ADDENDUM NO. 1 TO PROJECT NOS. 41696

**CONSTRUCTION WORK, HVAC WORK, PLUMBING WORK, ELECTRIC WORK
REPAIR CELL BACKS AND UPGRADE HVAC & PLUMBING BLOCK H
GREEN HAVEN CORRECTIONAL FACILITY
594 ROUTE 216
STORMVILLE, NEW YORK 12582-0010**

March 20, 2013

DWG NO:
M-106

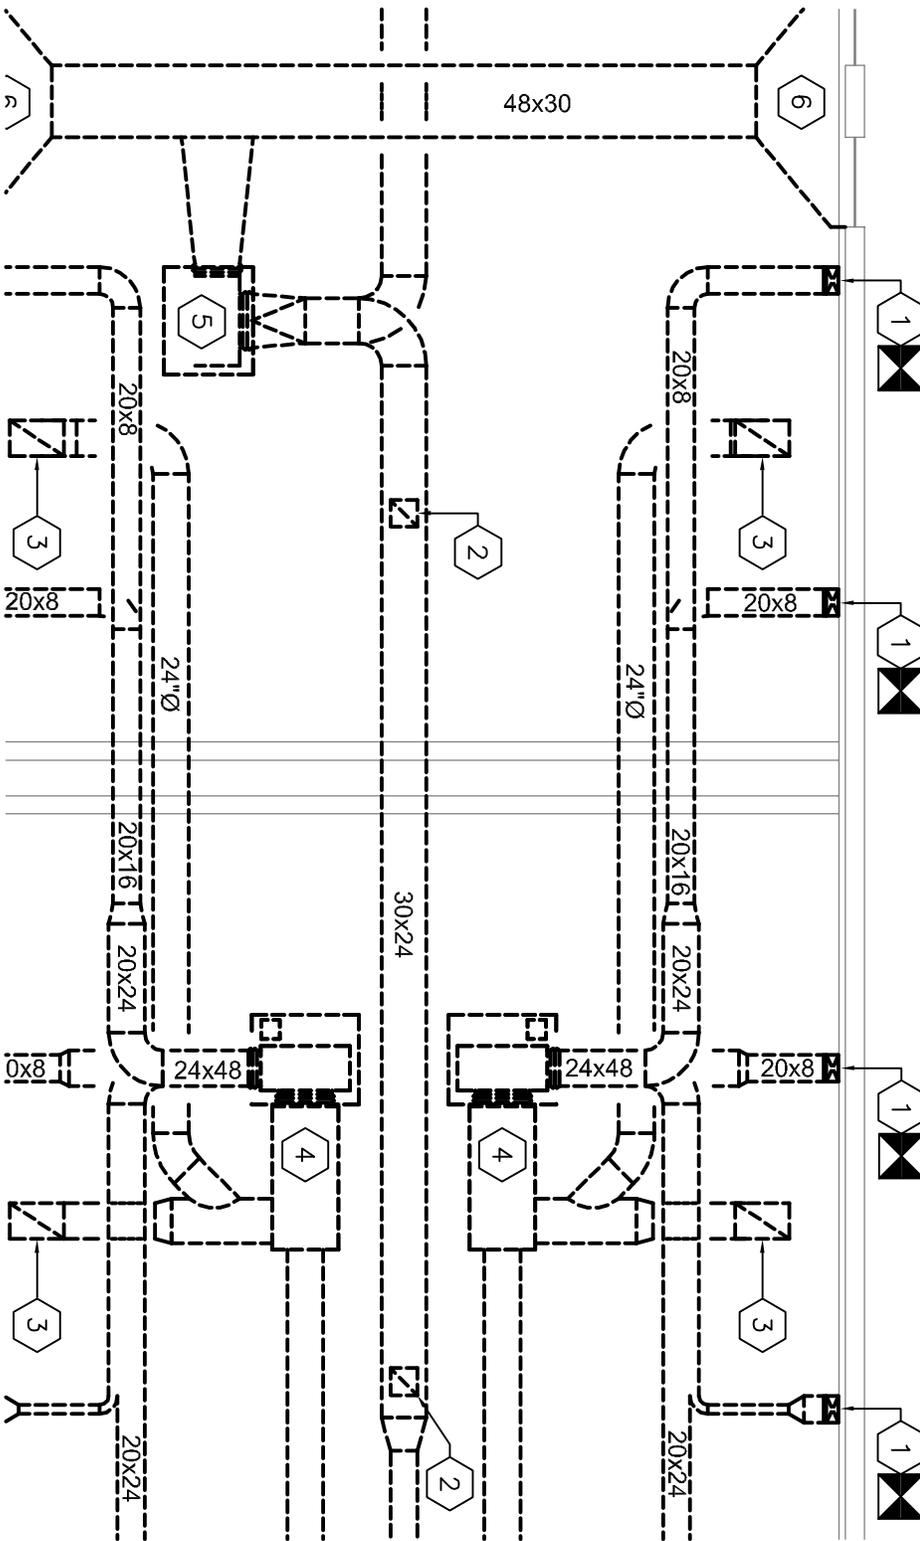
SHEET TITLE:
ADD GENERAL NOTES TO M-102

- A. ALL EQUIPMENT, PIPING, AND DUCTWORK THAT IS TO BE REMOVED FROM THE ATTIC MUST BE BROKEN DOWN TO FIT THROUGH A 5 FT. BY 5 FT. OPENING IN THE ATTIC (FORMERLY THE LOUVER OPENING).
- B. THE EXISTING ATTIC FLOOR SYSTEM HAS VERY LITTLE RESERVE CAPACITY FOR CONSTRUCTION LOADING. DO NOT STORE/STOCKPILE CONSTRUCTION TOOLS, MATERIALS, AND/OR MECHANICAL EQUIPMENT ON THE ATTIC FLOOR DURING CONSTRUCTION.

DWG NO:
M-107

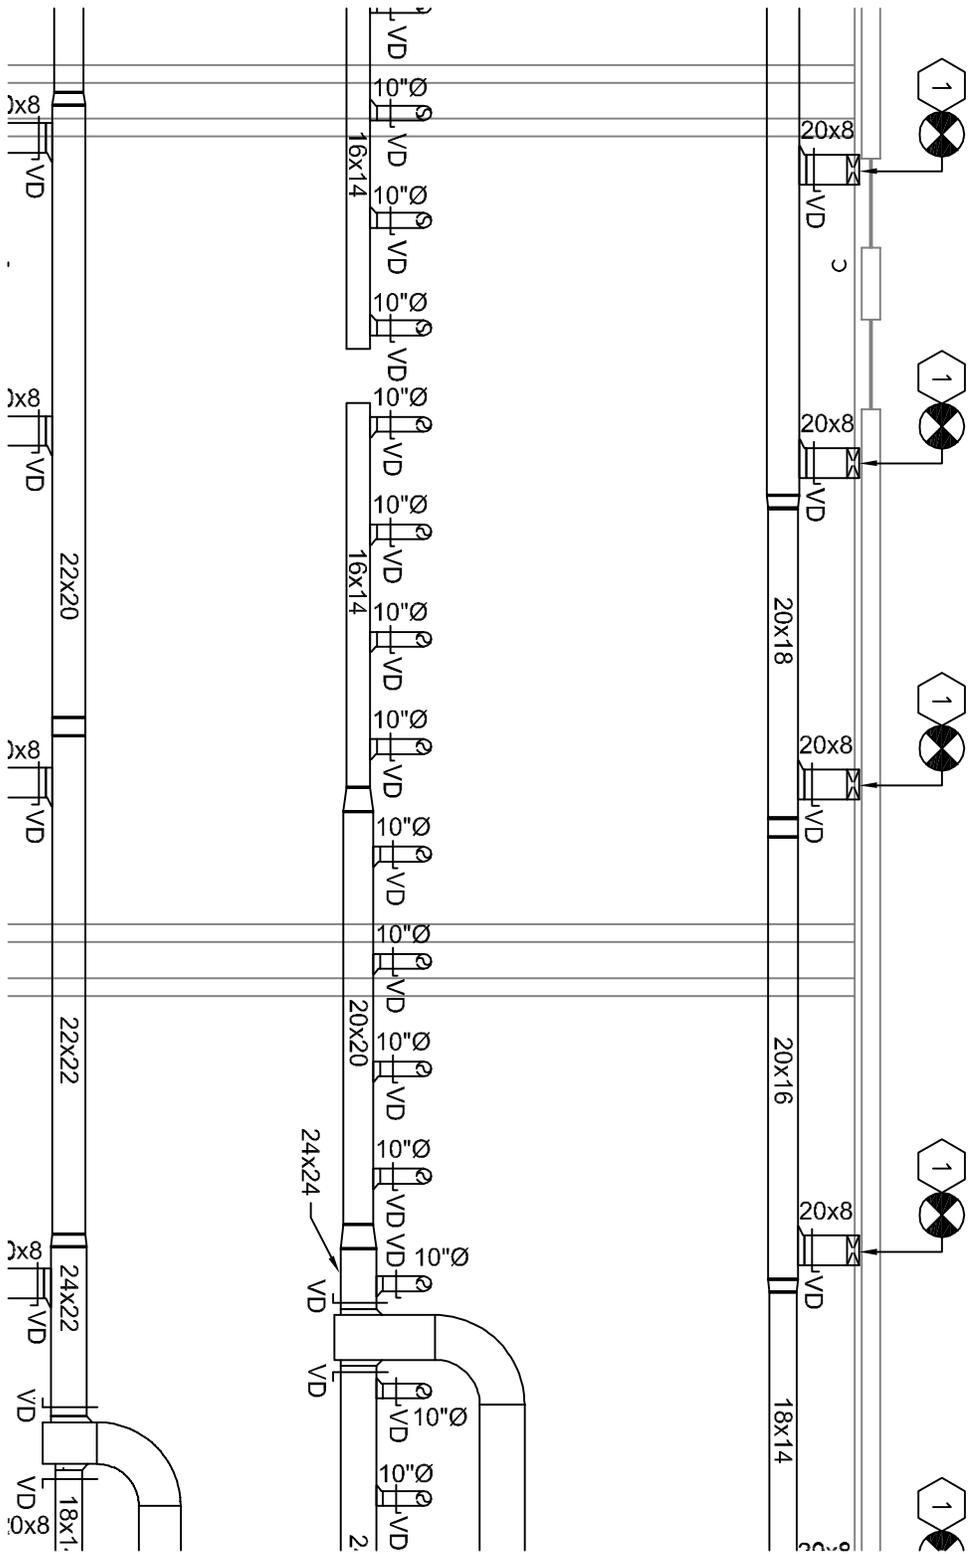
SHEET TITLE:
ADD GENERAL NOTES TO M-105

- A. ALL EQUIPMENT, PIPING, AND DUCTWORK THAT IS TO BE REMOVED FROM THE ATTIC MUST BE BROKEN DOWN TO FIT THROUGH A 5 FT. BY 5 FT. OPENING IN THE ATTIC (FORMERLY THE LOUVER OPENING).
- B. THE EXISTING ATTIC FLOOR SYSTEM HAS VERY LITTLE RESERVE CAPACITY FOR CONSTRUCTION LOADING. DO NOT STORE/STOCKPILE CONSTRUCTION TOOLS, MATERIALS, AND/OR MECHANICAL EQUIPMENT ON THE ATTIC FLOOR DURING CONSTRUCTION.
- C. COORDINATE TIMING OF CUTTING WITH C-CONTRACT. OVERSIZING DUCT HOLES SHALL NOT BE PERMITTED.

DWG NO:
 M-503

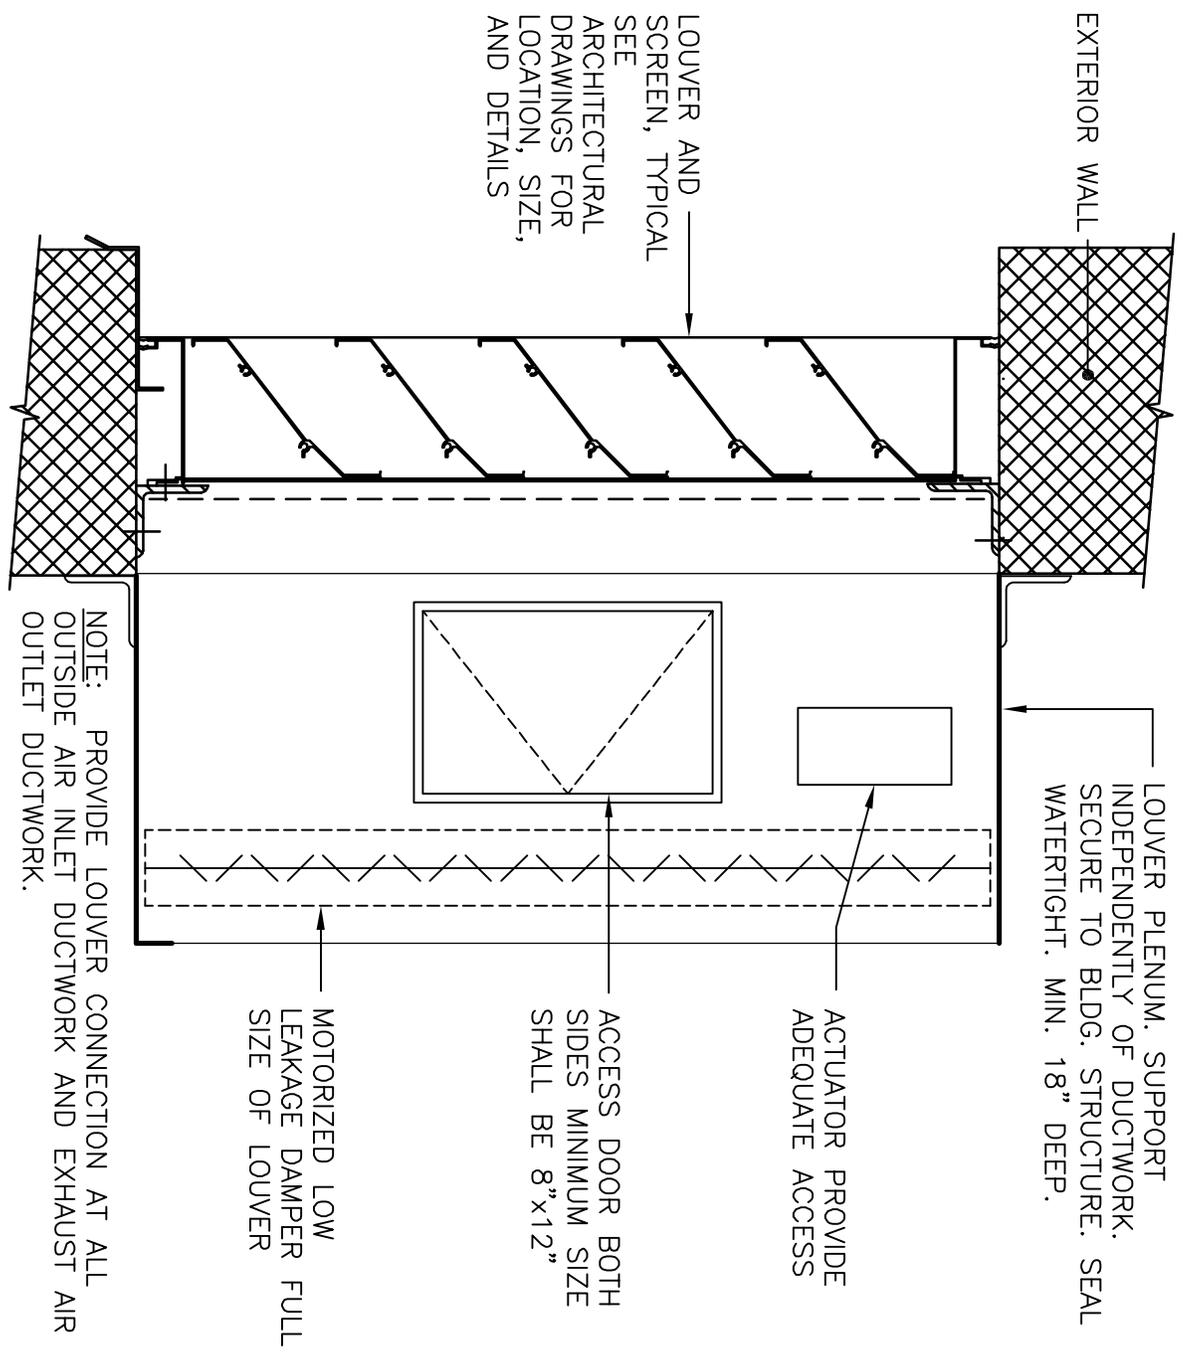
6. **Add** Drawing M-106 dated March 18, 2013. Drawing accompanies this Addendum and forms part of the Contract Documents.
7. **Add** Drawing M-107 dated March 18, 2013. Drawing accompanies this Addendum and forms part of the Contract Documents.
8. **Add** Drawing M-503 dated March 18, 2013; **ADD DETAIL 5 TYPICAL LOUVER CONNECTION**. Drawing accompanies this Addendum and forms part of the Contract Documents.
9. **Add** Drawing M-701 dated March 18, 2013; **REVISE DETAIL 4**. Drawing accompanies this Addendum and forms part of the Contract Documents.

SHEET TITLE:
 ADD DETAIL 5 TO M-502

TYPICAL LOUVER CONNECTION DETAIL

NOTE: PROVIDE LOUVER CONNECTION AT ALL OUTSIDE AIR INLET DUCTWORK AND EXHAUST AIR OUTLET DUCTWORK.

MOTORIZED LOW LEAKAGE DAMPER FULL SIZE OF LOUVER

ACCESS DOOR BOTH SIDES MINIMUM SIZE SHALL BE 8"x12"

LOUVER PLENUM. SUPPORT INDEPENDENTLY OF DUCTWORK. SECURE TO BLDG. STRUCTURE. SEAL WATERTIGHT. MIN. 18" DEEP.
